Duane Arnold Energy Center
Docket No. 50-331
Renewed Facility Operating License No. DPR-49

Subject: License Amendment Request (TSCR-149), Revision to Staff
Augmentation Times in the Duane Arnold Energy Center Emergency Plan

License Amendment Request (LAR) for Revision to Staff Augmentation Times in the
Duane Arnold Energy Center Emergency Plan

Figure B-1
ON-SITE EMERGENCY RESPONSE ORGANIZATION (pg. 1 of 2)

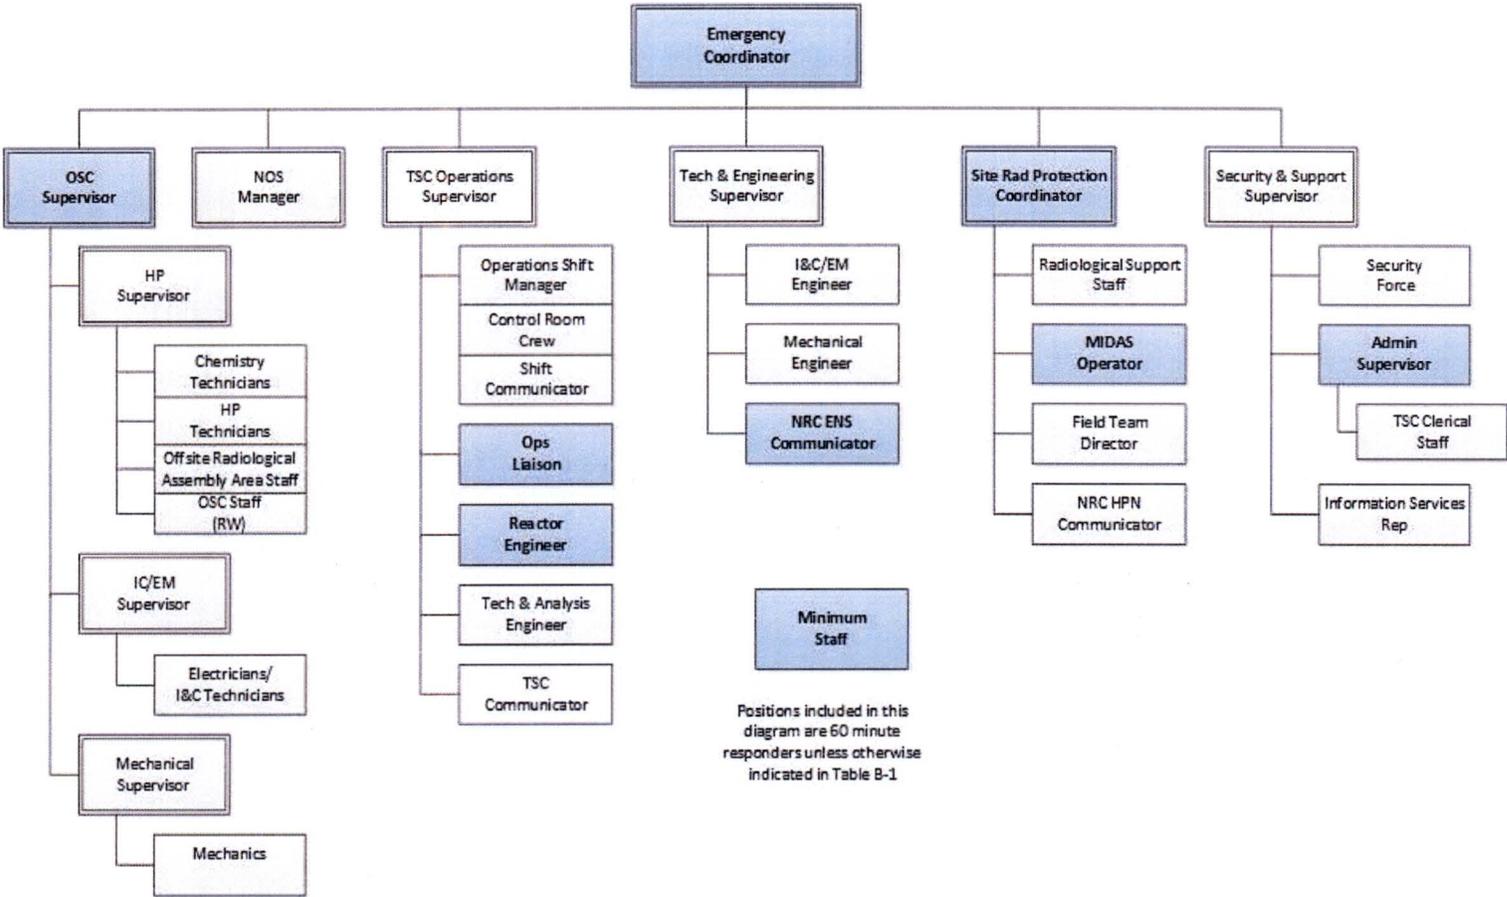
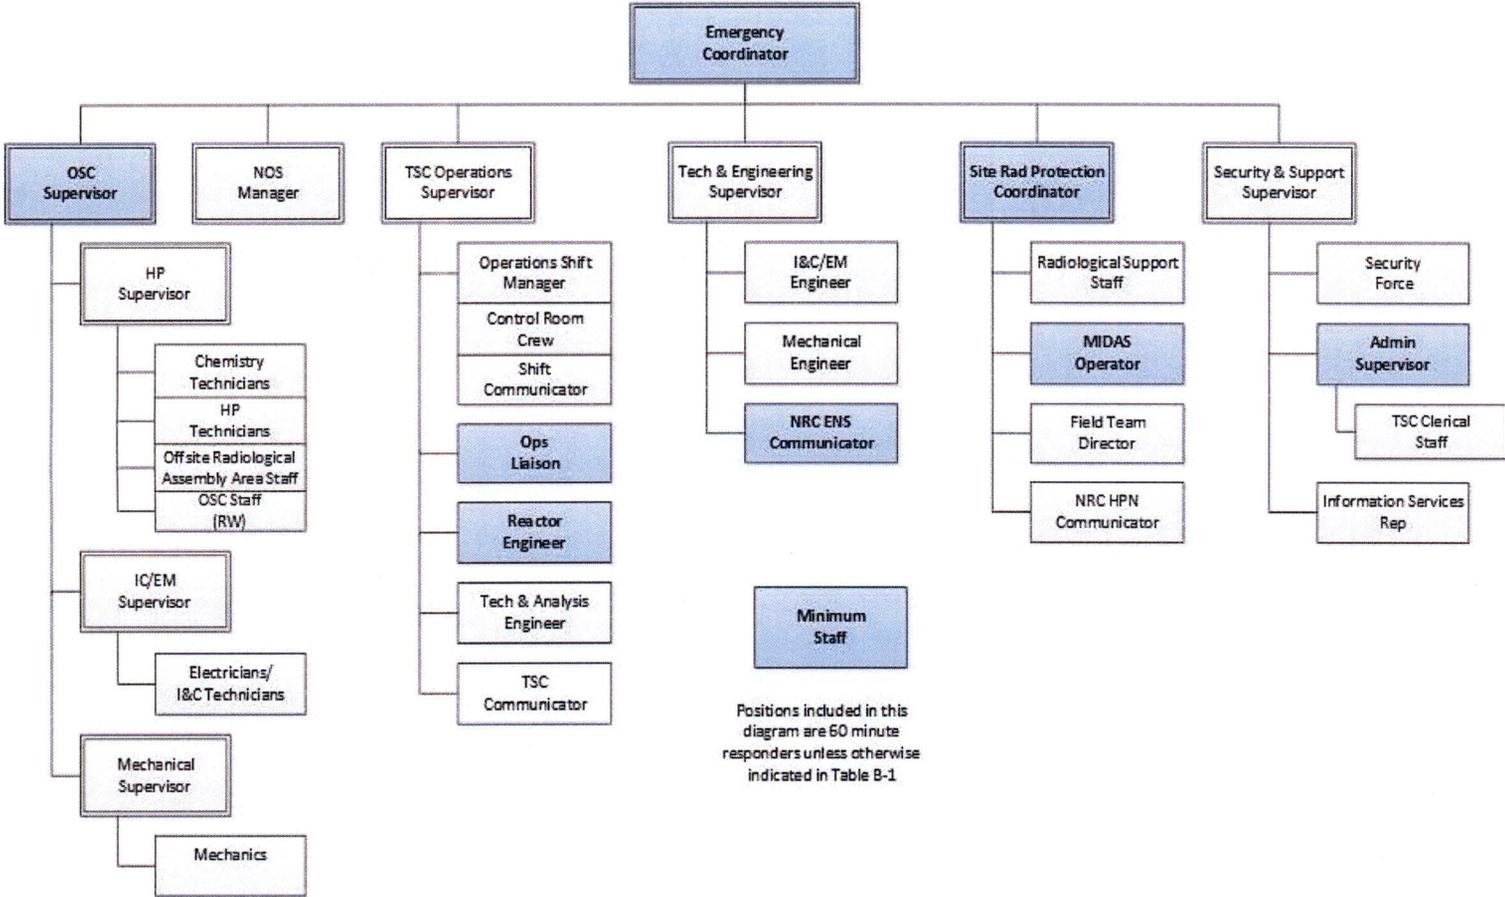
- i. Section B, "Emergency Response Organization," Figure B-1 was updated to reflect the positions designated as minimum staff within the Emergency Response Facilities.

The proposed revision to DAEC Emergency Plan Section B, Figure B-1, requires augmentation of the on-shift staff by the following TSC positions which support activation of the TSC within 60 minutes of an Alert classification:

Figure B-1
CORPORATE EMERGENCY RESPONSE ORGANIZATION (pg. 2 of 2)

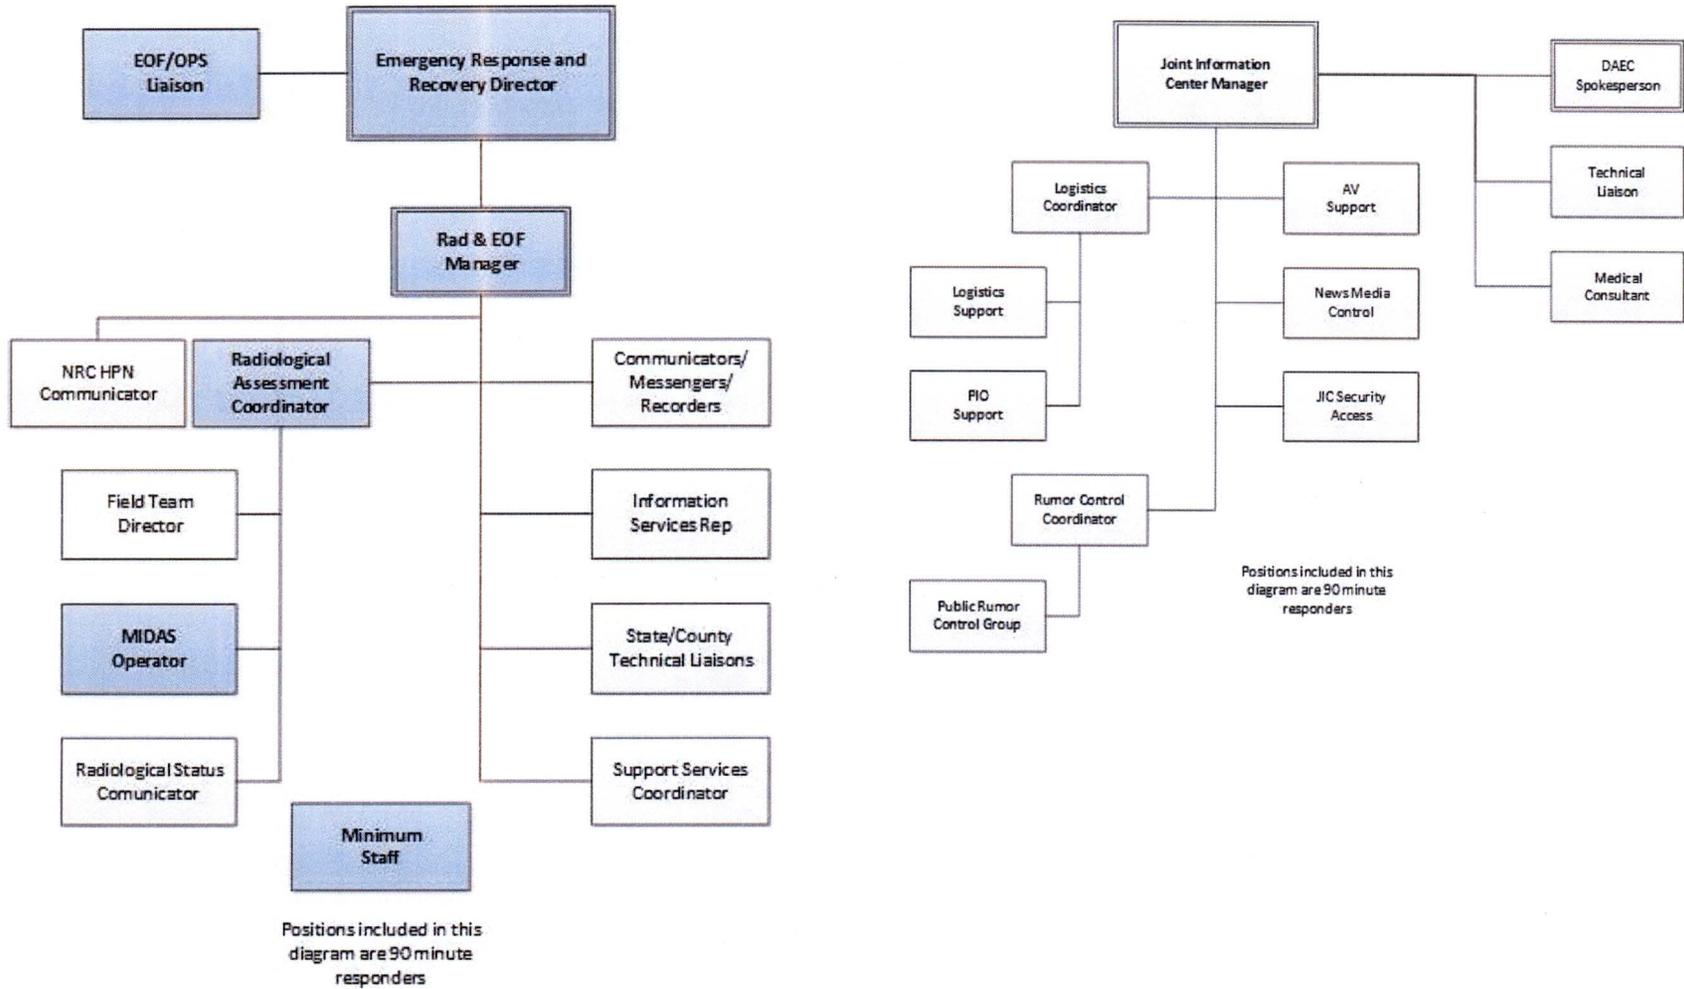
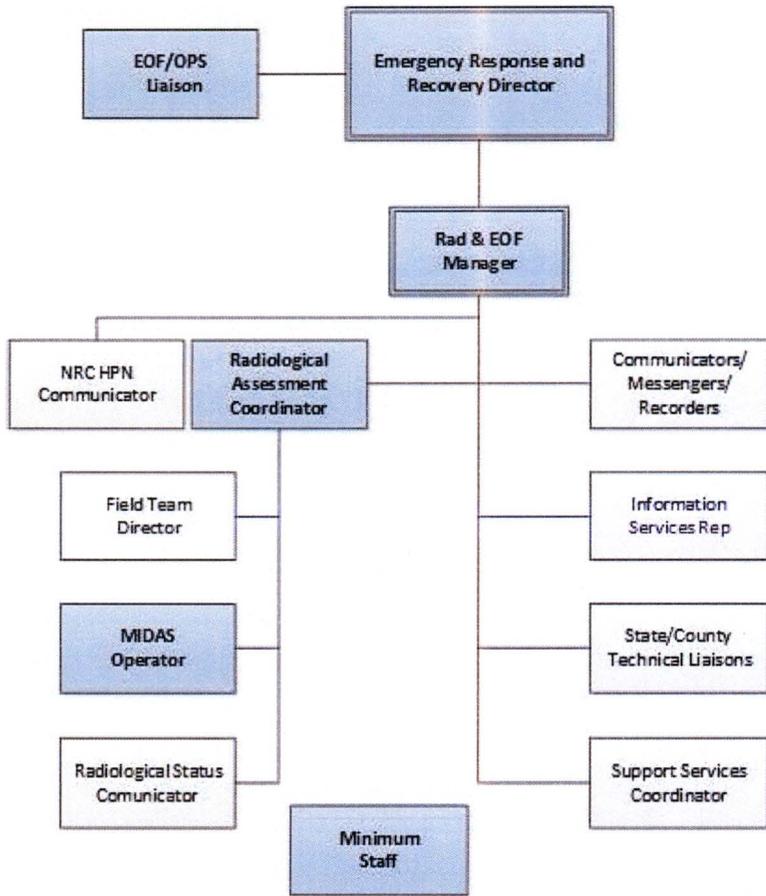
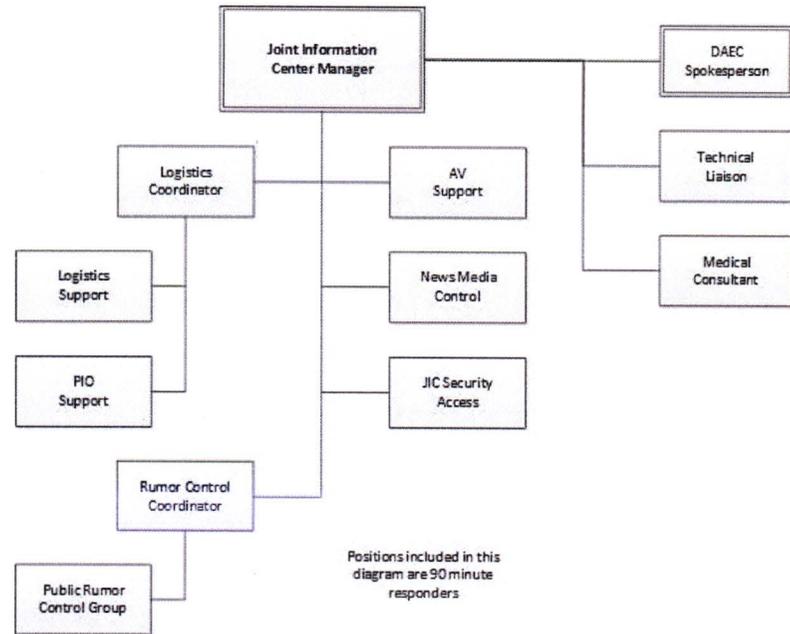
Positions included in this diagram are 90 minute responders
